Virginia Electric and Power Company
ATTN: Mr. W. L. Proffitt
Senior Vice President - Power
P. O. Box 26666
Richmond, Virginia 23261

The Commission has issued the enclosed Amendments No. 20 to Facility Operating Licenses Nos. DPR-32 and DPR-37 for the Surry Power Station Units Nos. 1 and 2. These amendments consist of changes to the Technical Specifications in response to your two applications dated March 11, 1976, as supplemented May 12, and 14, 1976.

These amendments relate to both the increase in the limiting nuclear enthalpy hot channel factor (F_{AH}^N) for Surry Units Nos. 1 and 2 and to the replacement of 81 of 157 fuel assemblies in the reactor core of Surry Unit No. 2 constituting refueling of the core for third cycle operation.

Amendment No. 20
License No. DPR-32

FIGURE 3.12-1B CONTROL BANK INSERTION LIMITS FOR NORMAL 3 LOOP OPERATION - UNIT 2

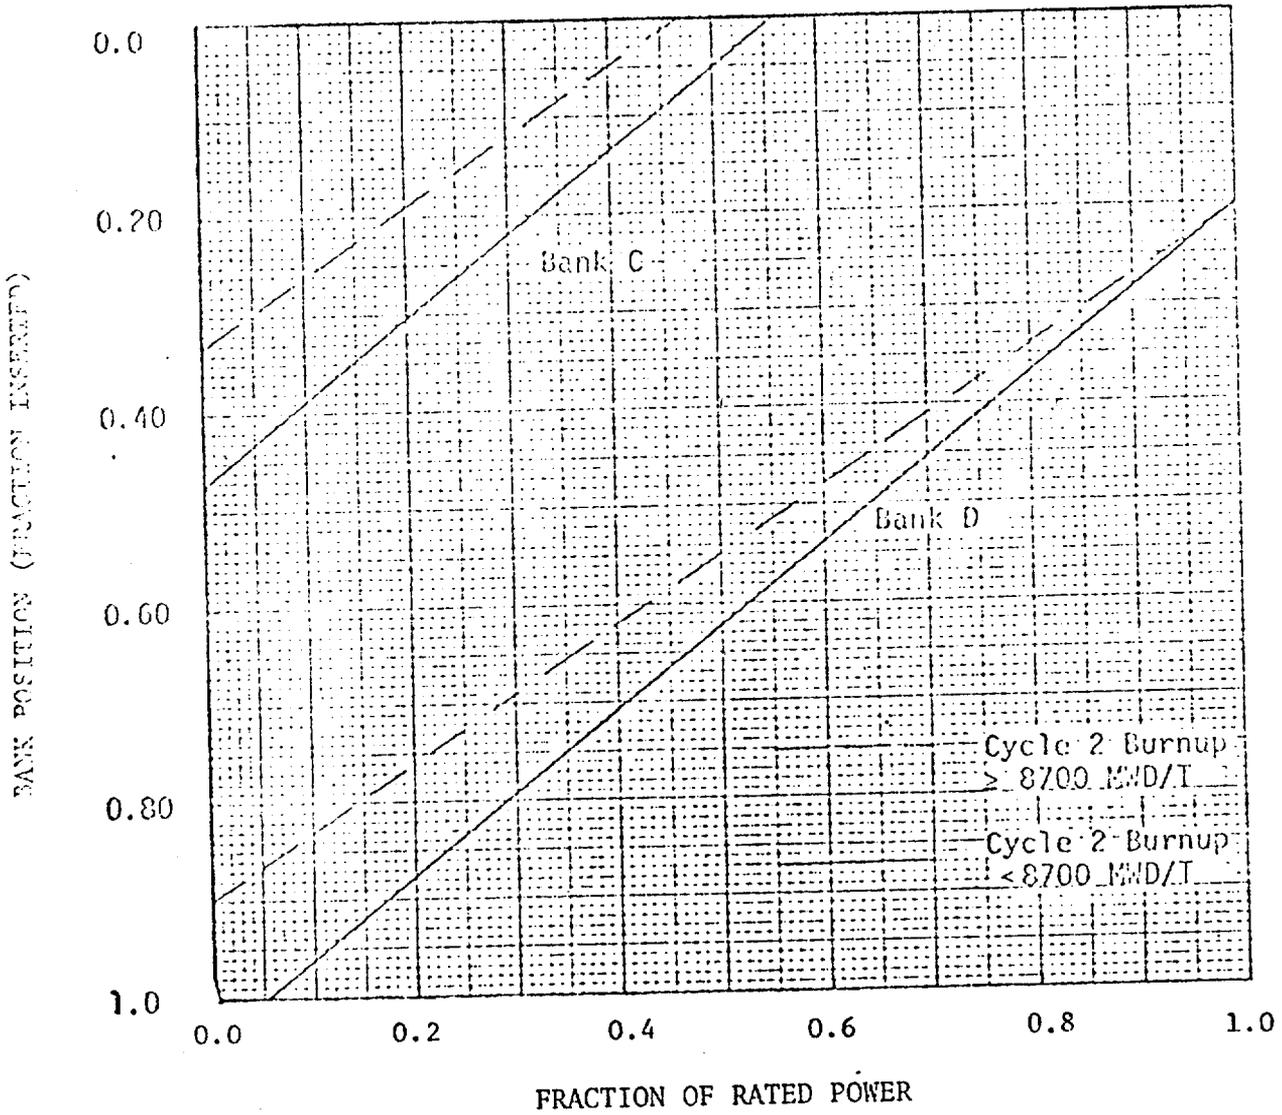
The licensee has proposed for Unit No. 2 only (Reference 1) a Technical Specification change on the rod insertion limits for Cycle 3 operation. Those limits, as discussed in this report, are acceptable.
